TENNESSEE VALLEY AUTHORITY
CHATTANOOGA, TENNESSEE 37401
400 Chestnut Street Tower II

Enclosed for NRC review are TVA's responses to NRC concerns resulting from the NRC Fire Protection Review conducted at the Watts Bar Nuclear Plant on July 20-24, 1981. It is our understanding that these concerns will be discussed at the fire protection meeting scheduled for September 2, 1981 in Bethesda, Maryland.

ENCLOSURE
WATTS BAR NUCLEAR PLANT UNITS 1 AND 2
RESPONSES TO NRC FIRE PROTECTION SITE VISIT CONCERNS

Item 6

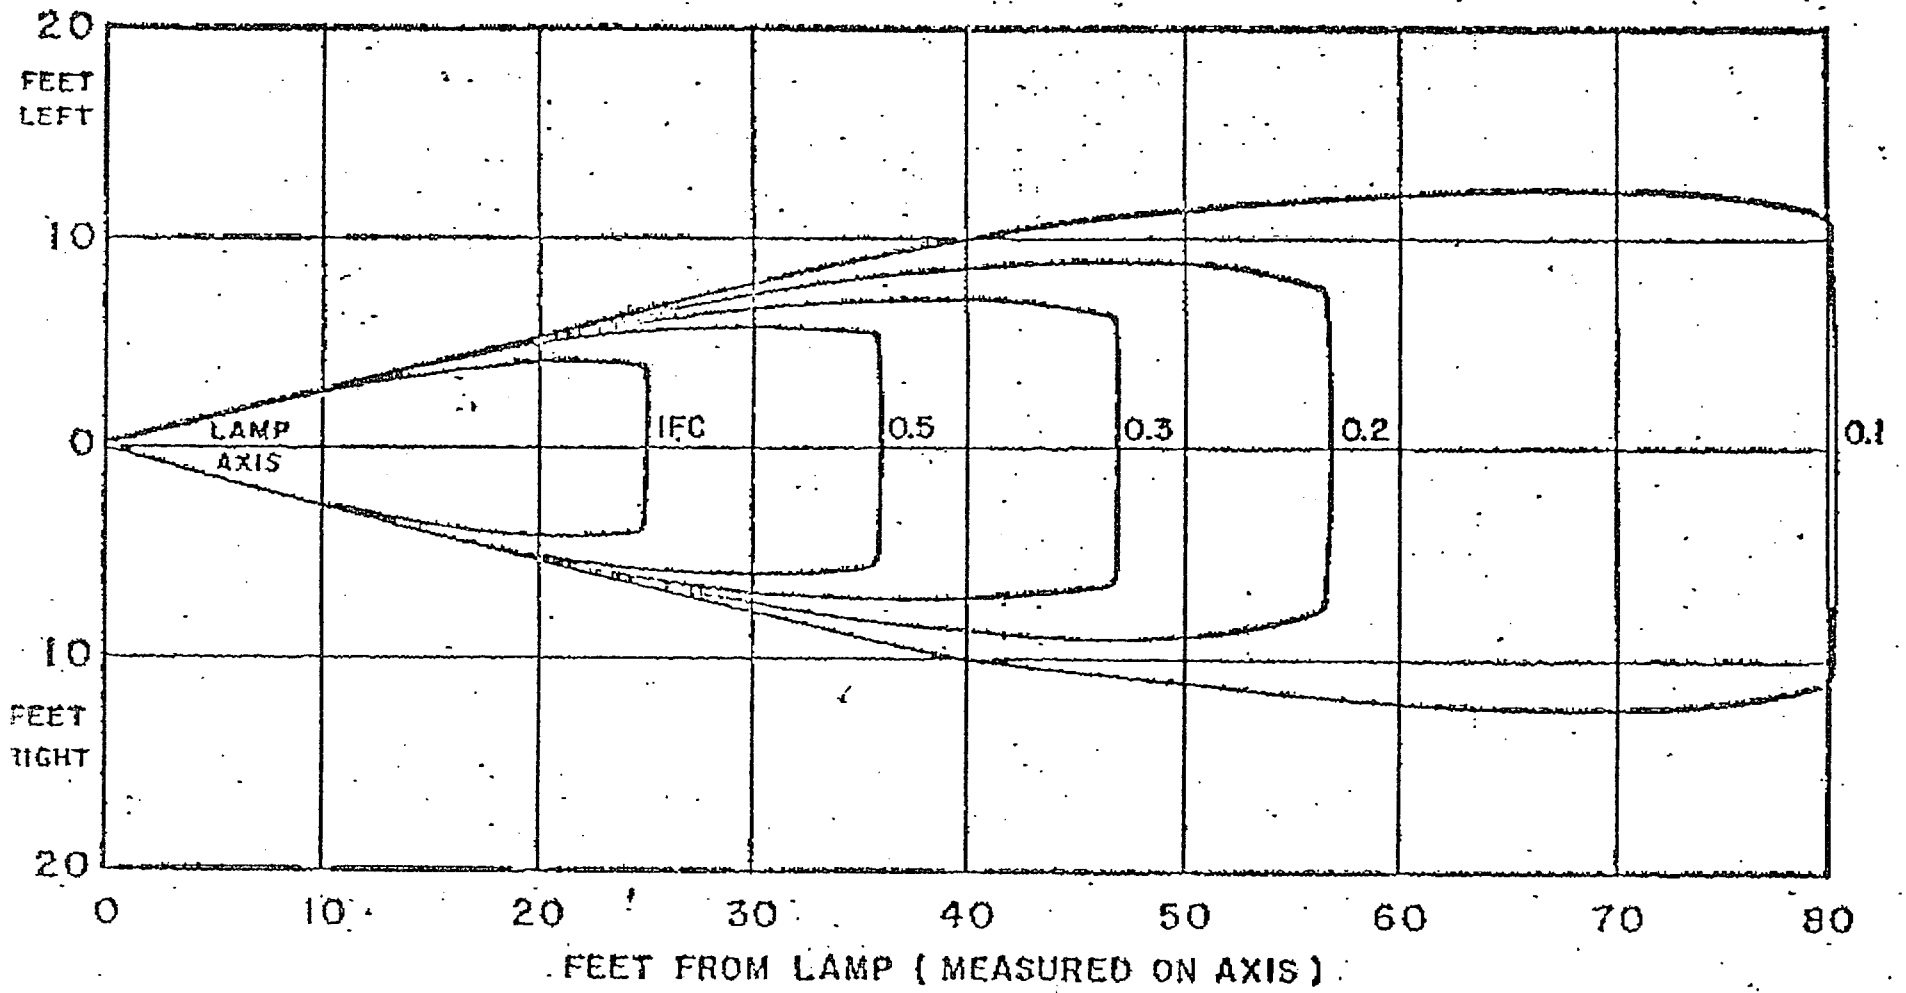
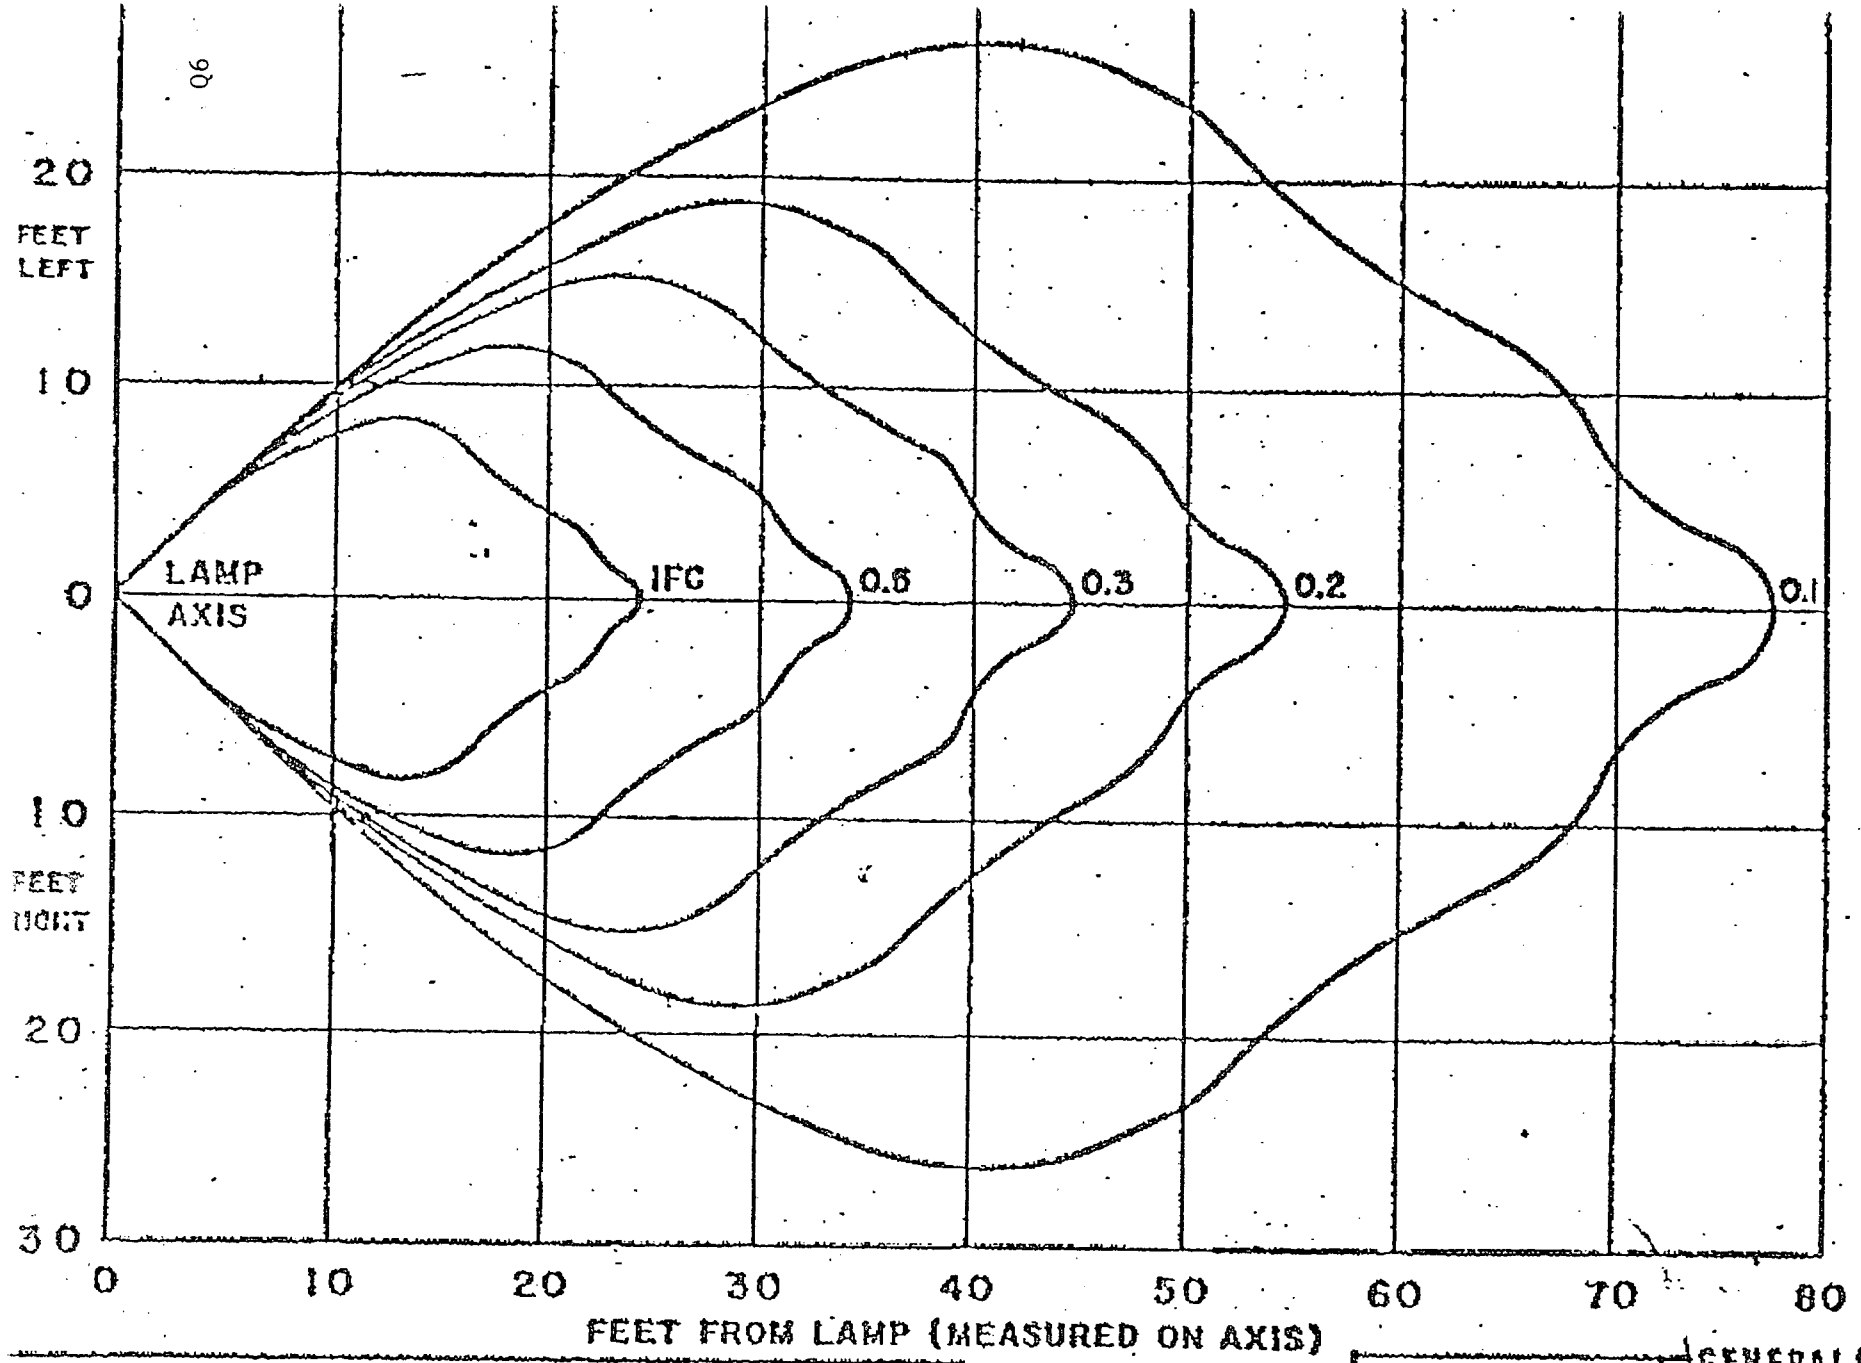
At present, 1-1/2 hour fixed emergency seal beam lighting is provided incorporating smaller capacity bulbs such that approximately 8 hour duration is provided. We find this arrangement unacceptable since the distance of light in a given area is also reduced. It is our position to meet the guideline of Section D.5 of Appendix A to BTP 9.5-1, that fixed emergency sealed beam units with individual 8 hour minimum battery power supplies be provided in areas that must be manned for safe shutdown and for access and egress routes to and from all fire areas. Safe shutdown areas include those required to be manned if the control room must be evacuated.

The fixed self-contained emergency lighting units purchased for Watts Bar Nuclear Plant have a nameplate indicating a rating of 1-1/2 hours when supplying four 25-watt PAR-36 lamps. Each unit is also capable of supplying one 25-watt PAR-36 lamp for 8 hours. The units installed at Watts Bar utilize two 10-watt PAR-36 halogen cycle lamps which allow the batteries to be upgraded to 8-hour capacity. A comparison of the 150 foot candle distribution curve for the 10-watt lamp (see General Electric curve 381-A-1487, figure 6-1) with the distribution curve of the standard 25-watt lamp (see General Electric curve 381-A-1208, figure 6-2) indicates that the two 10-watt lamps produce approximately the same illumination level as two of the 25-watt lamps.

The emergency lighting system at Watts Bar Nuclear Plant is essentially the same as that for Sequoyah Nuclear Plant. A recent SNP Special Test No. 7, 'Simulated Loss of All Onsite and Offsite AC Power' (L. M. Mills letter to Ms. Adensen dated June 5, 1981) was conducted for the purpose of verifying that critical plant operation can be performed using emergency lighting. The results of the test were satisfactory.

It is TVA's position that the emergency lighting system is adequate for the intended service.

Item 20

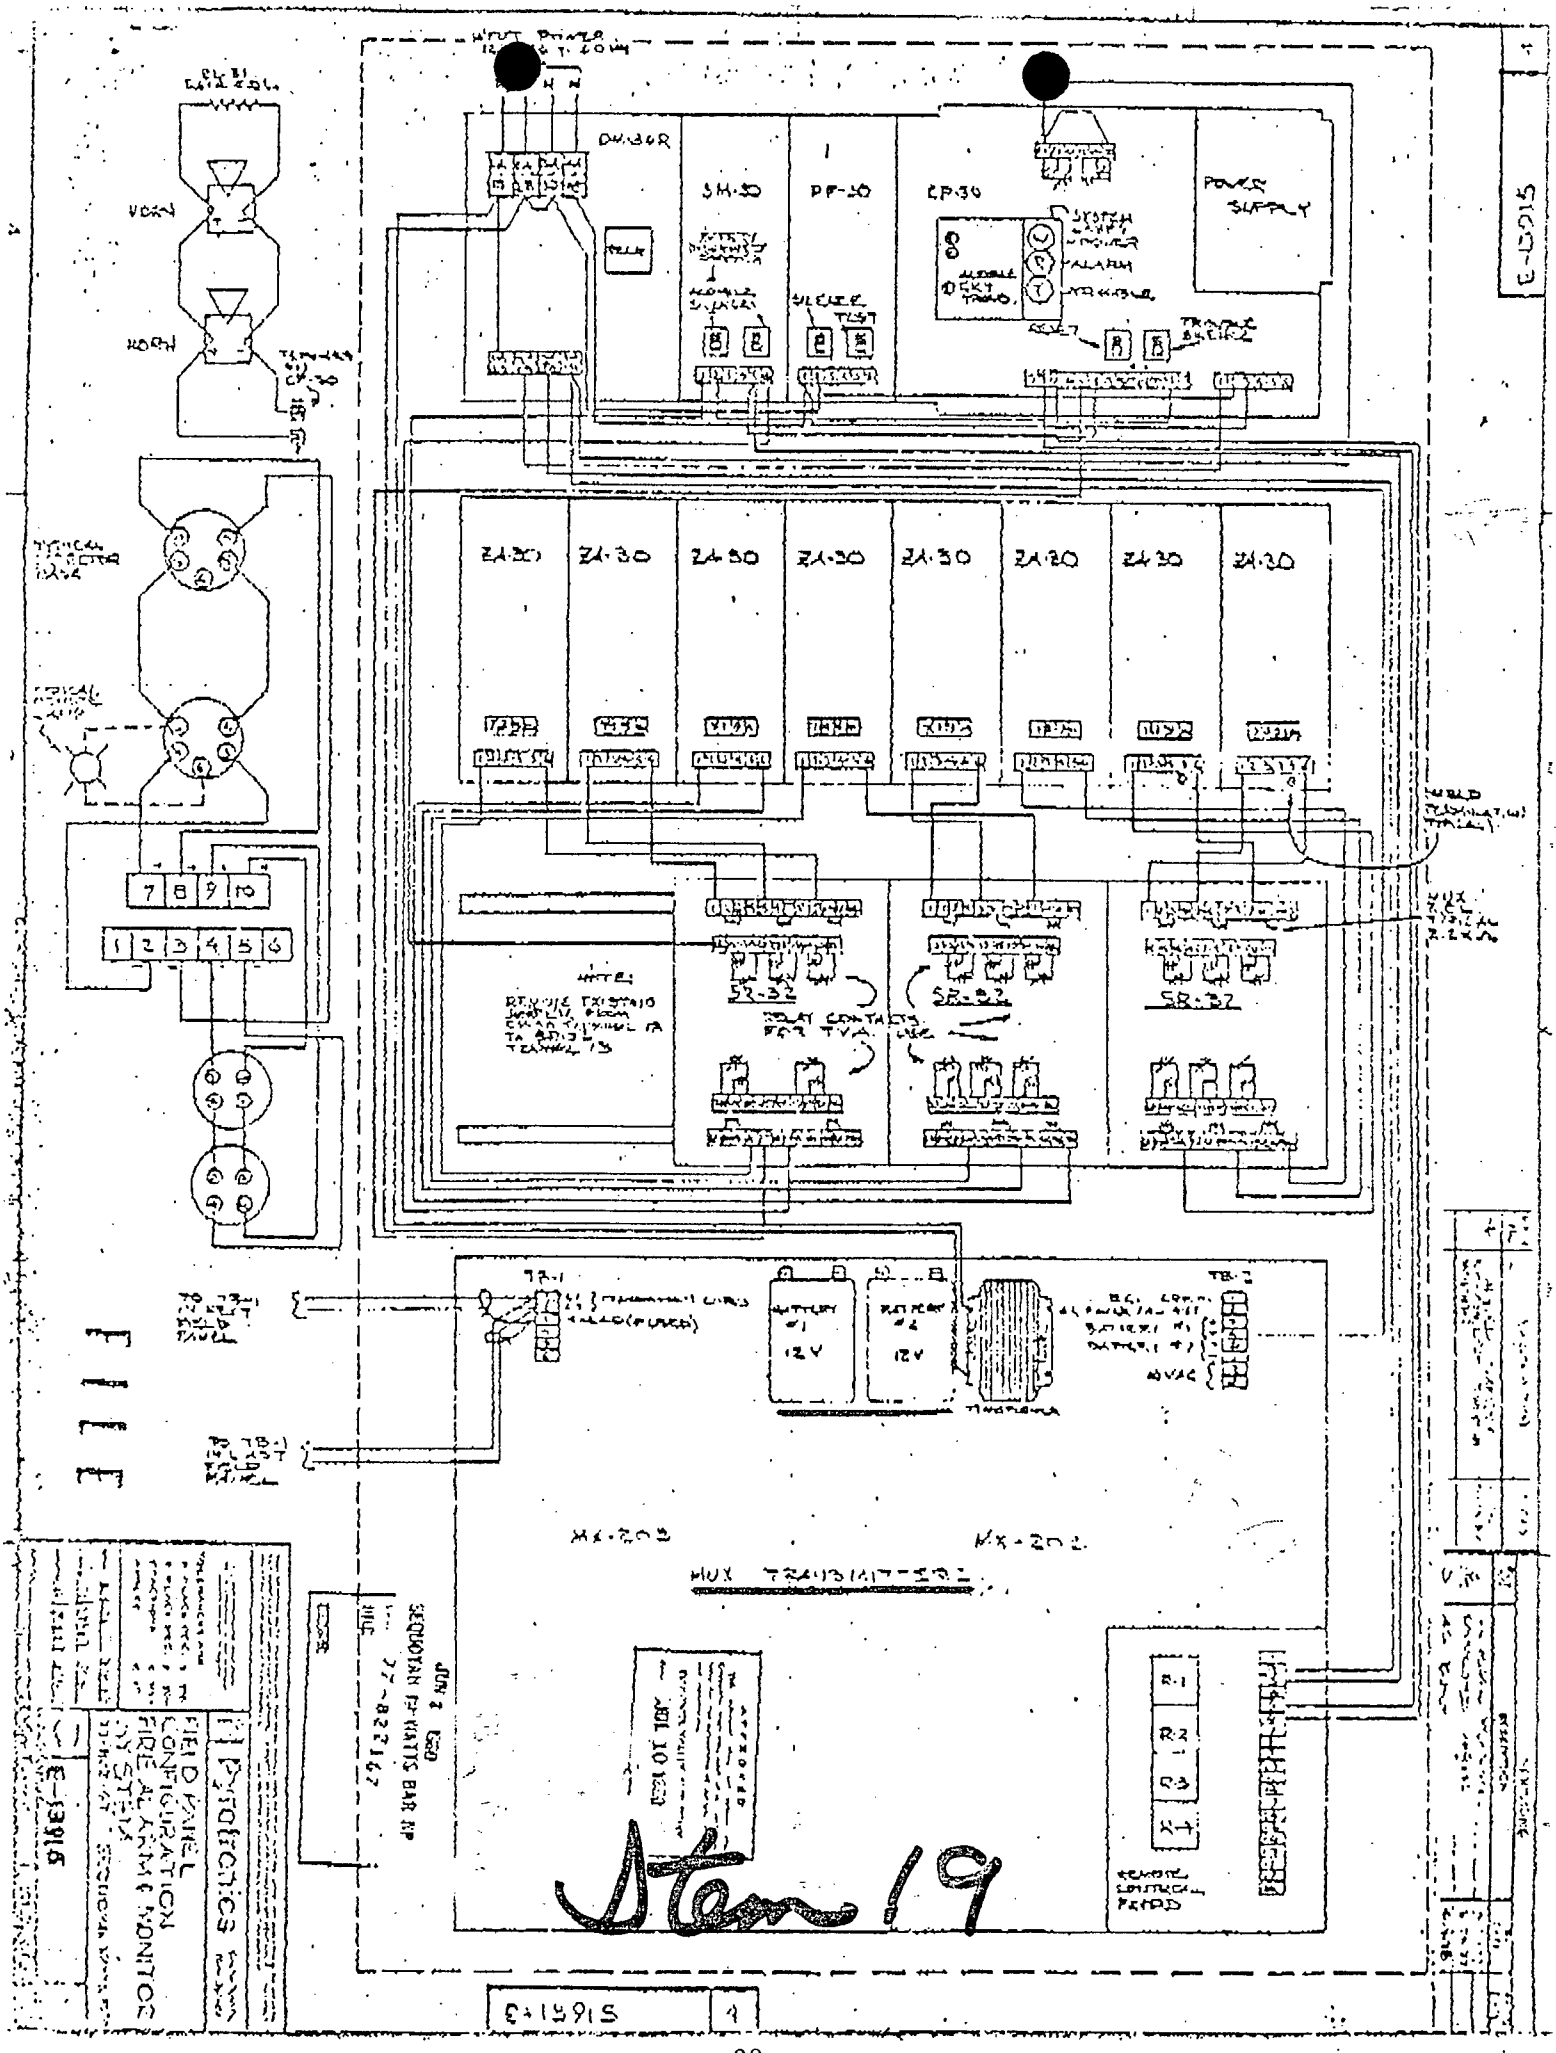
At present each local fire alarm control panel is hard-wired to its power supply. We are concerned that a ground or open on this power supply circuit will leave one or more fire alarm control panels without power, thereby eliminating all fire detection for the area. Also communication between the microprocessor in the control room and these fire alarm control panels, located at various locations throughout the plant, is provided by a digital data modems.

We are also concerned that an alarm condition from fire detectors to the local fire alarm control panel activates circuits in the FACP for the control of automatic suppression system in the area on unsupervised circuits. In order to meet the guidelines of Section E.1 of Appendix A to BTP 9.5-1, it is our position that:

1. A four-hour battery supply be provided for each local fire alarm control panel.

2. Each fire alarm control panel should have its own modem located in or adjacent to the fire alarm control panel.

3. All control functions from local FACPs to valves, etc., should be on supervised circuits.

1. A vendor supplied four-hour battery supply electrical source is provided in each local fire alarm panel. The attached vendor drawing (Pyrotronics E-13915) shows the location of the four-hour battery installation. This system for standby power supply to the detection system is designed in accordance with NFPA 72D and complies with the requirements of Appendix A to BTP 9.5-1.

2. Each fire alarm local control panel does have its own MUX transmitter (Modem) located in the panel. The attached vendor drawing (Pyrotronics E-13915) shows the location of the transmitters.

3. In lieu of supervising all control functions from local panels to fire protection devices, TVA commits to perform surveillance testing of these circuits every six months. The Watts Bar Plant technical specifications will reflect this commitment.
